FORD:

2015 Edge

ISSUE

Some 2015 Edge vehicles equipped with a roof opening panel and built on or before 8/10/2015 may exhibit a rattle, pop, tap and/or tick noise coming from the roof at the top of the B-pillar. Noise can be heard above and behind the driver and/or passenger front seats.

Figure 2 - Article 16-0079

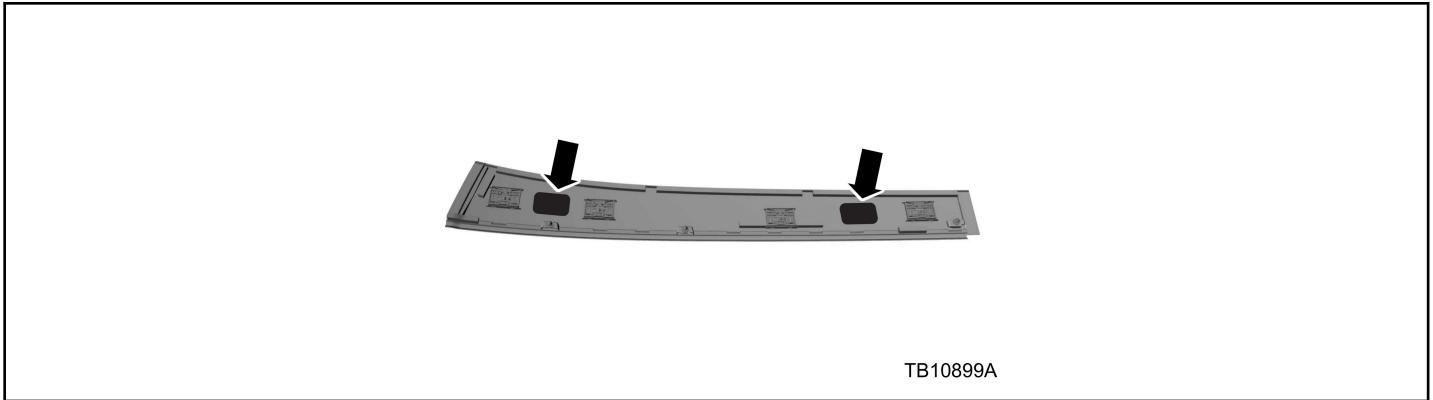
- a. Using a straightedge and a depth micrometer or other suitable measuring device, measure the depth of the indentation in the roof opening panel net pad. Subtract the measurement taken in Step 5 from this measurement to make sure a 2 mm (1/16") indentation has been made. If a 2 mm (1/16") indentation has not been made, repeat the step.
 - (1) Indenting the roof opening panel sheet metal more than 2 mm (1/16") may cause deformation of the roof opening panel frame. This may prevent the roof opening panel side trim panel from setting flush against roof opening panel glass.
- 8. Clean the roof opening panel side trim panel and roof sheet metal with isopropyl alcohol in the locations shown. (Figures 2-3)

- 9. Apply a one step urethane glass primer to the roof opening panel side trim panel in the locations shown. (Figure 2)
- 10. Apply a 10 mm (3/8") wide X 15 mm (9/16") tall bead of urethane adhesive a minimum of 30 mm (1-1/8") long to the roof opening panel frame in the locations shown. (Figure 3)
- 11. Reinstall the roof opening panel side trim panel. Refer to WSM, Section 501-17.
